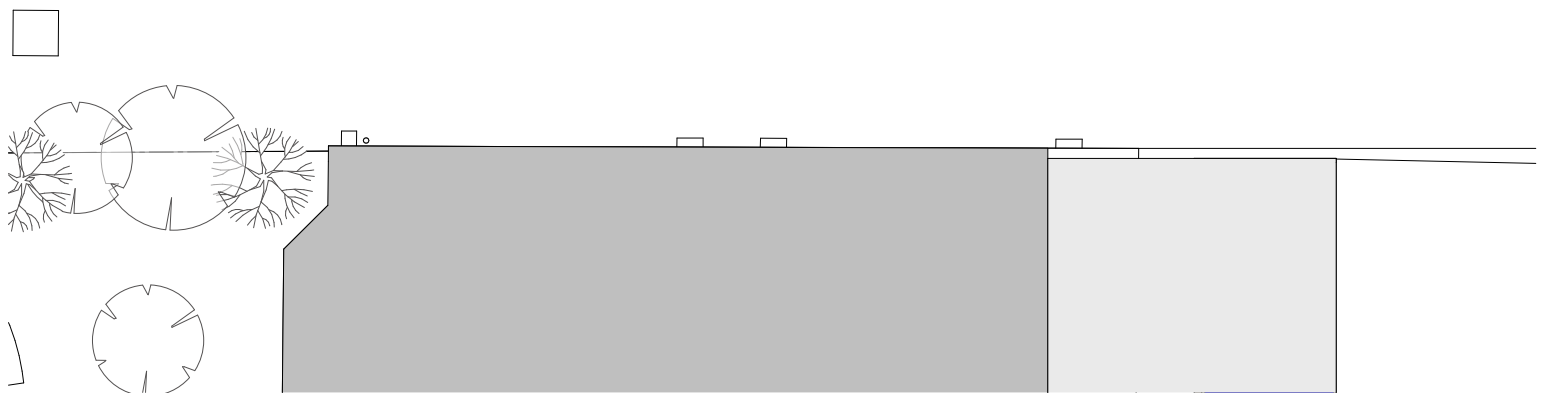
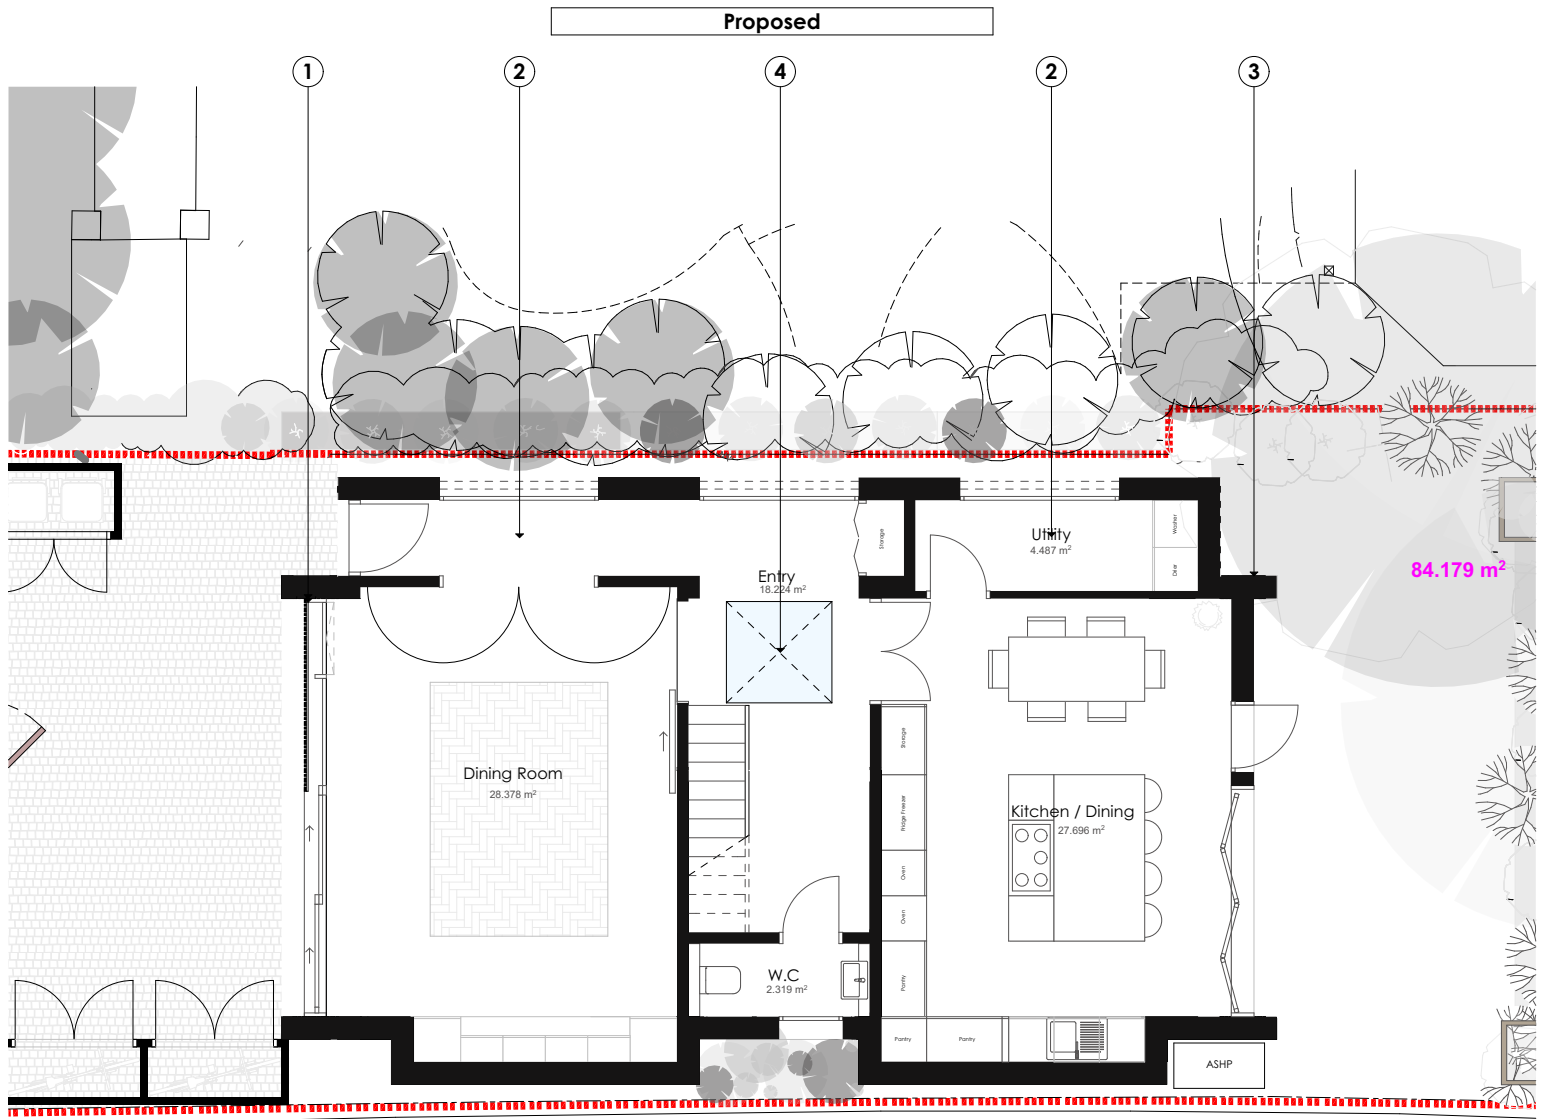
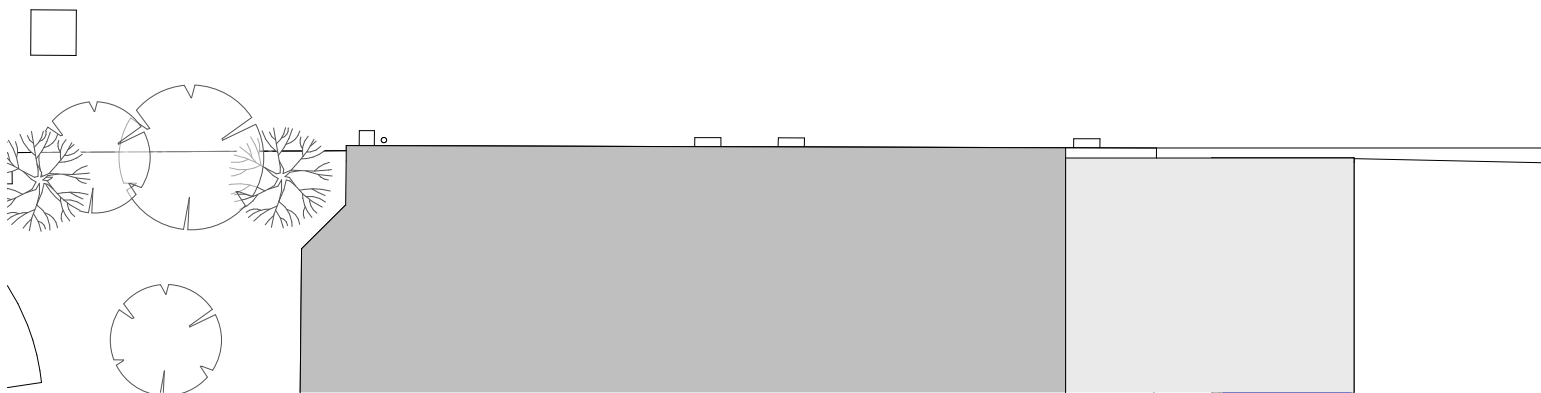
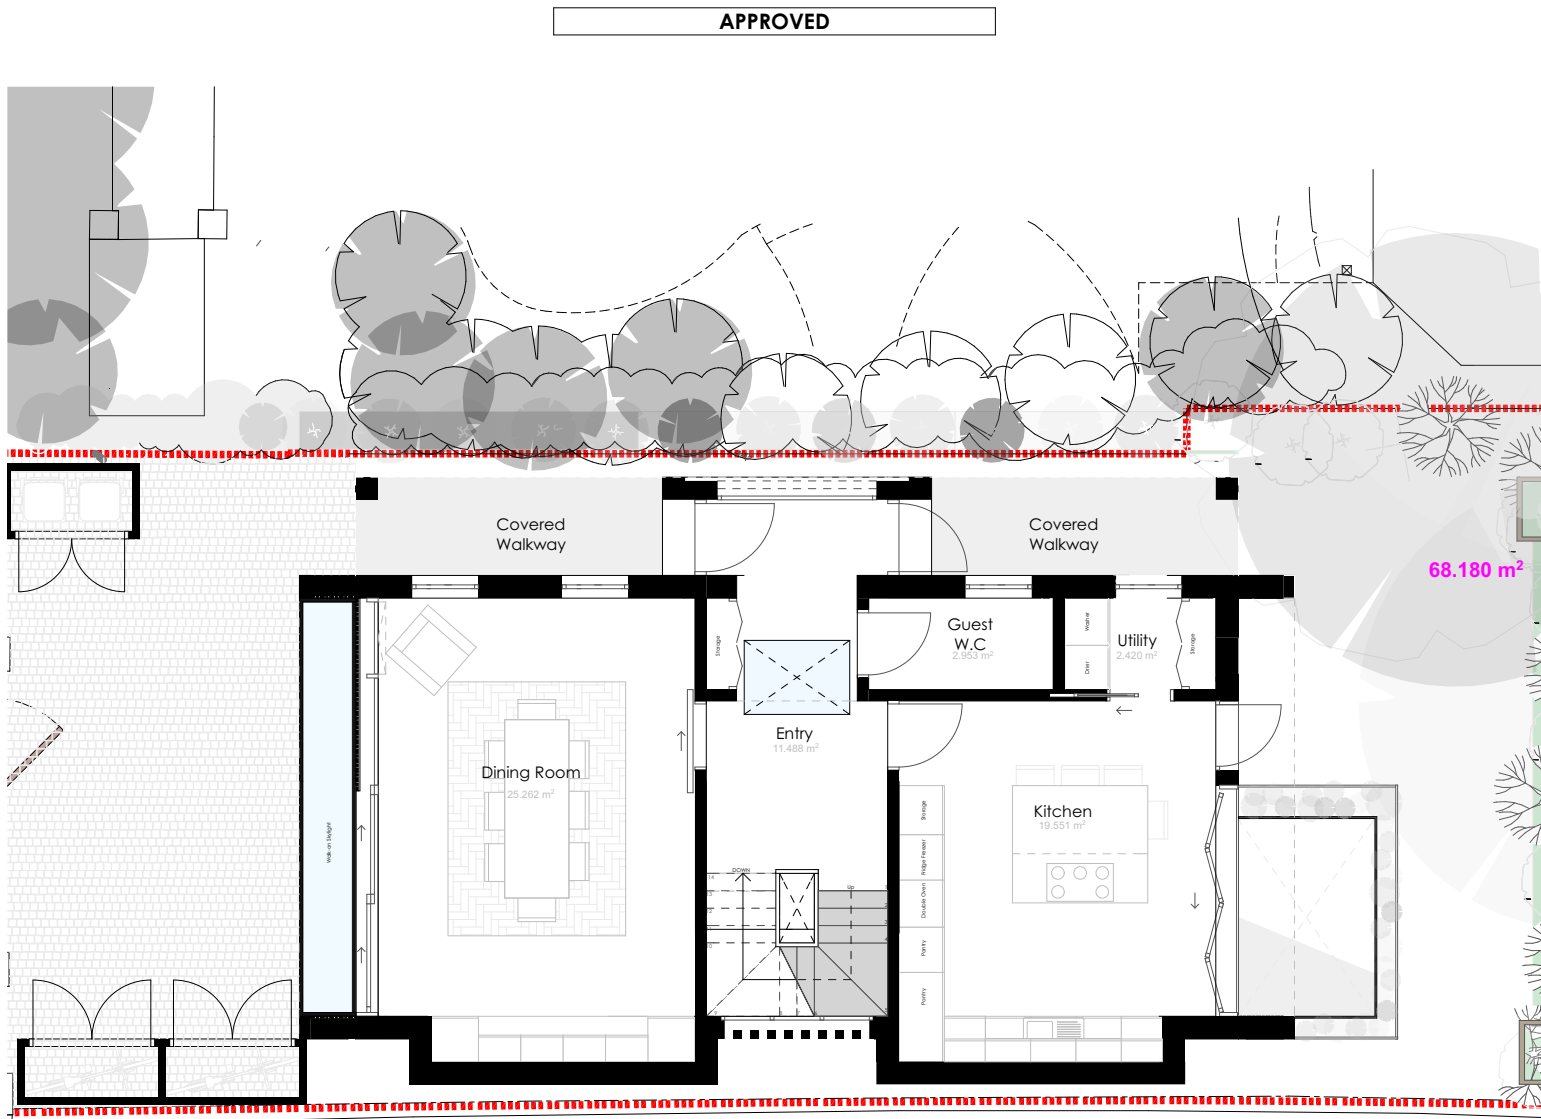
Changes:
(1) Removal of basement

- Changes:**
- (1) Ground floor front elevation brought forwards within overhang 450mm. Protrusion of overhang unchanged.
 - (2) Covered walkways at ground floor enclosed forming new entrance hallway at front of property, enlarged kitchen dining through relocated utility at rear of property. High level glazing on north elevation.
 - (3) Ground Floor rear elevation also brought forwards 450mm, overhang remains unchanged from approved.
 - (4) Enlarged Skylight

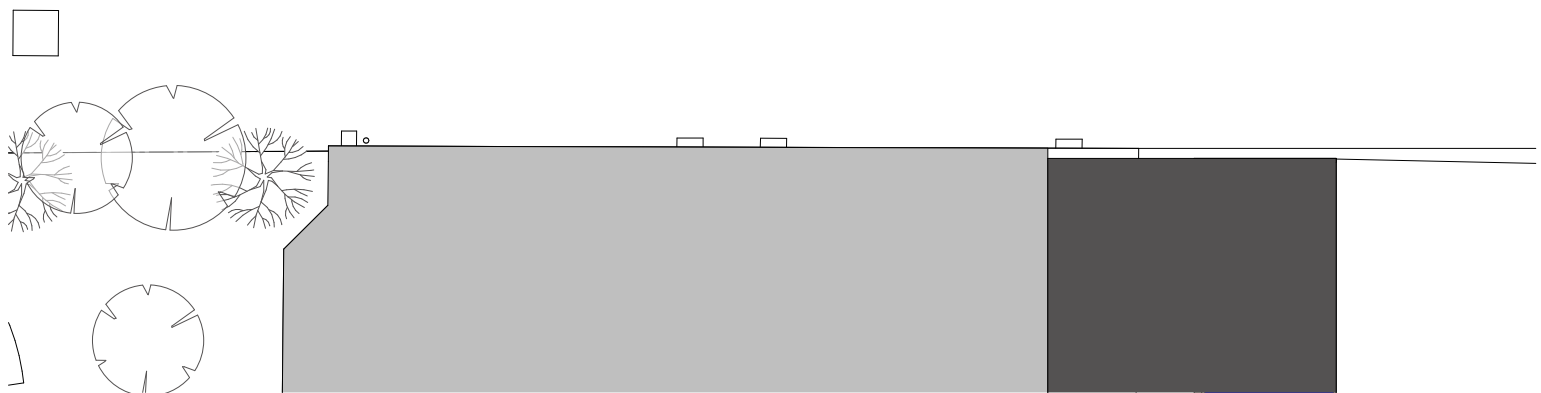
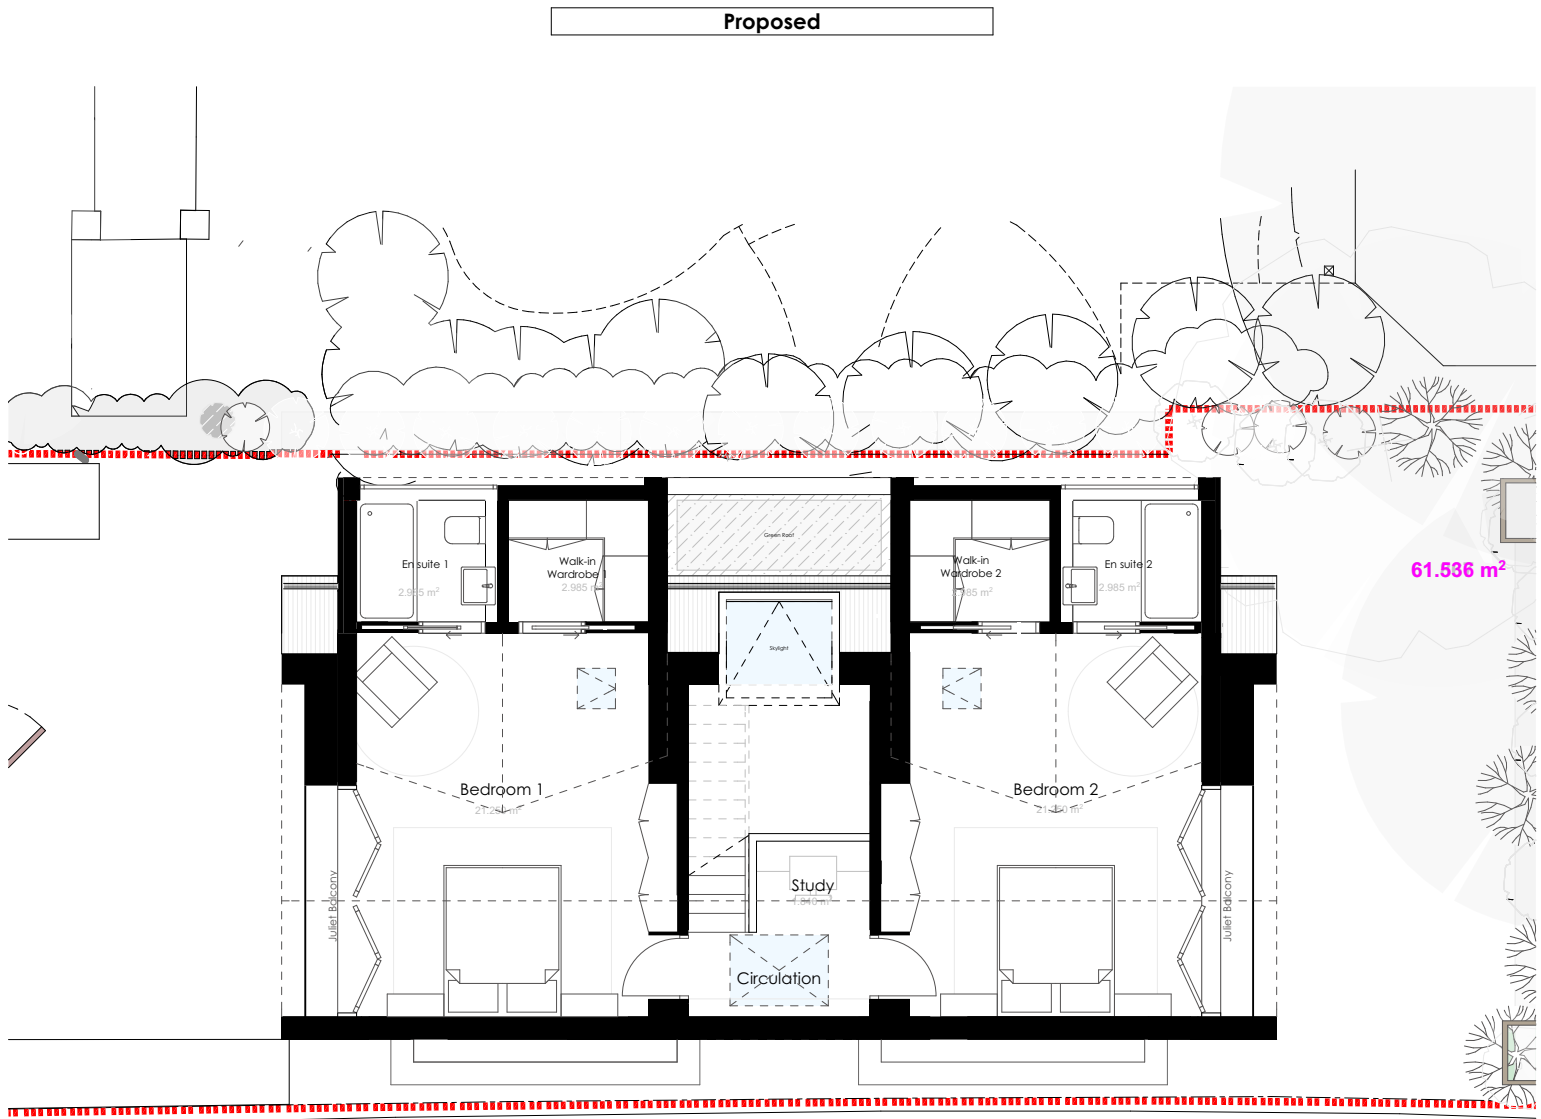
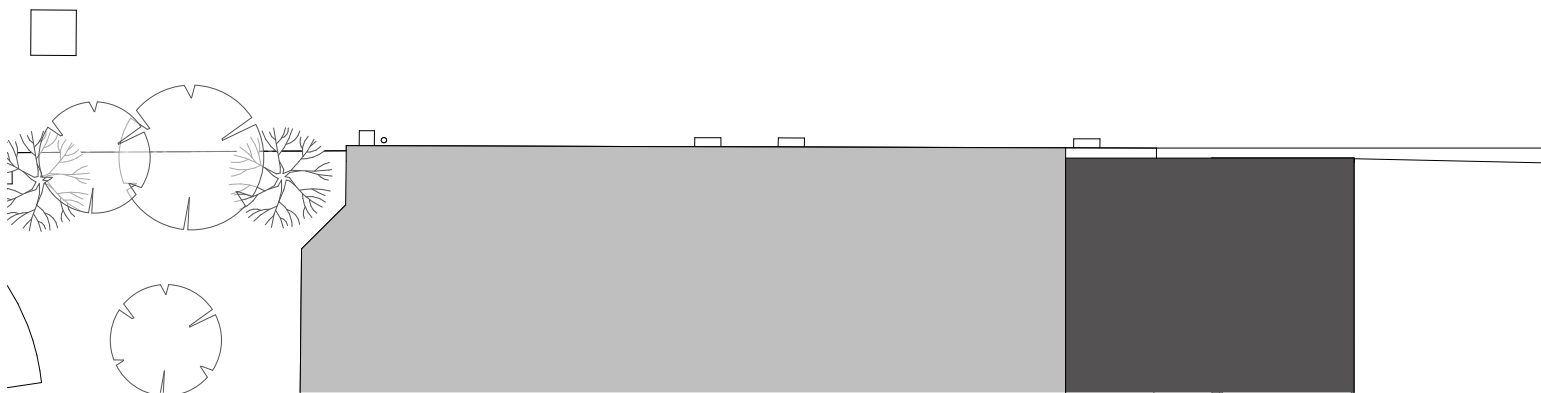
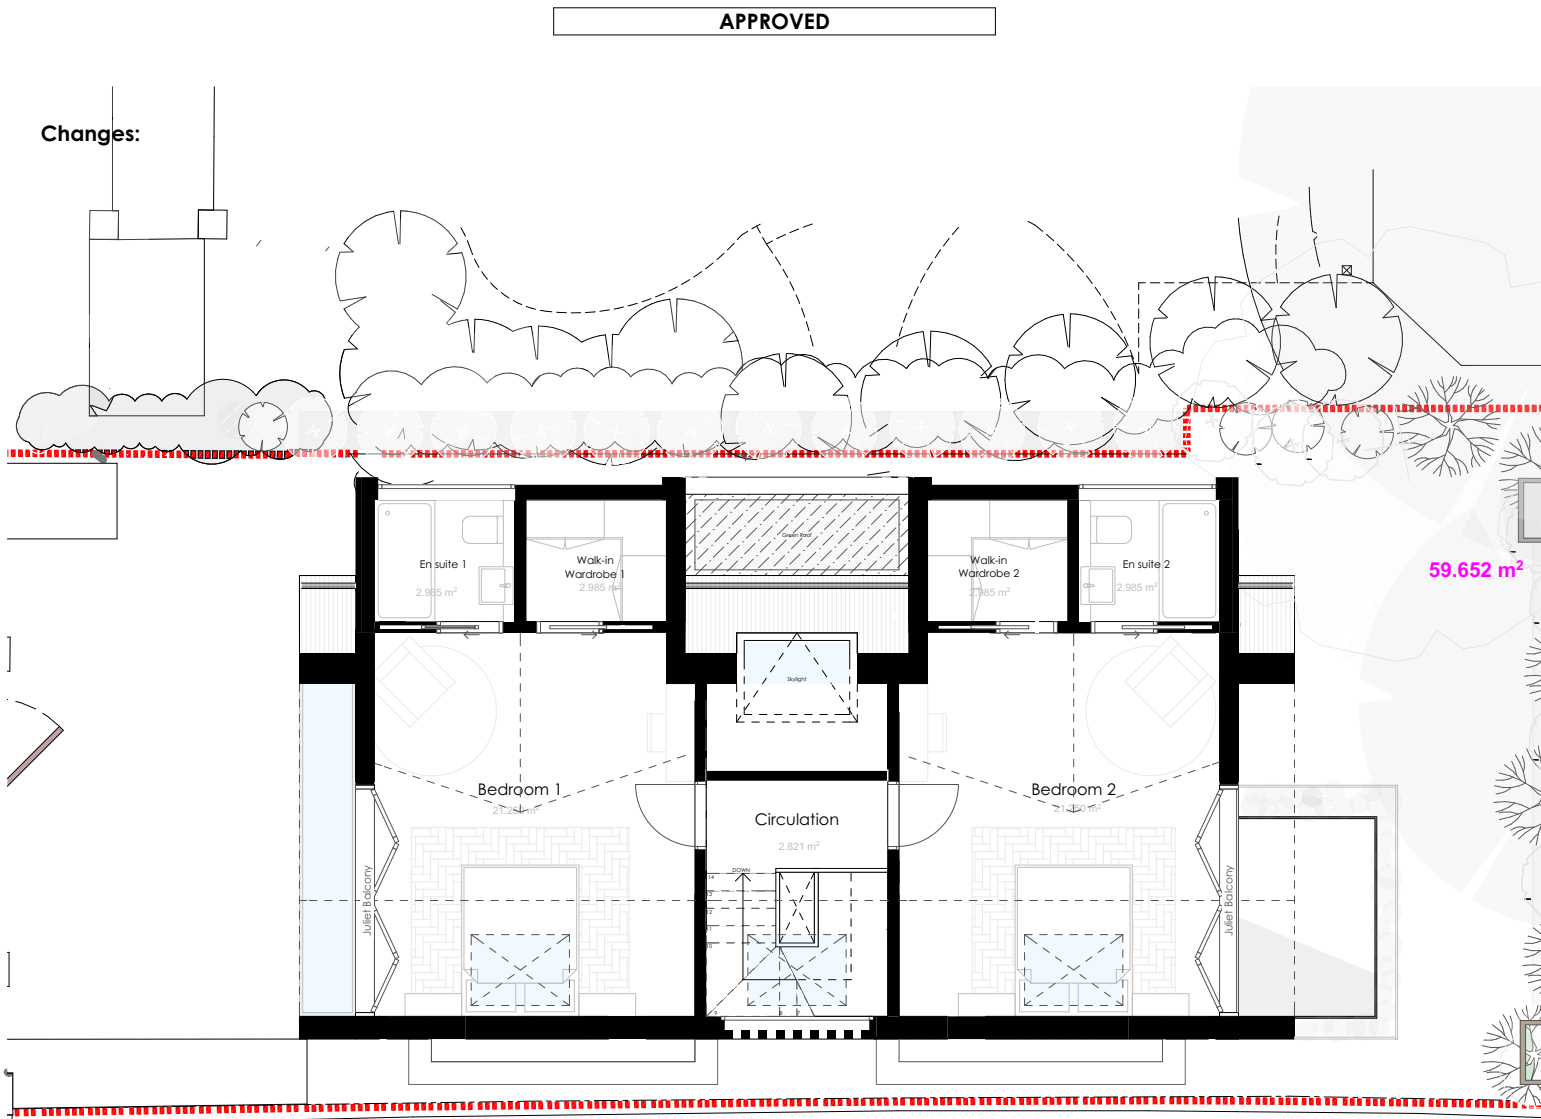
Changes:

1st Floor unchanged for purposes of planning.
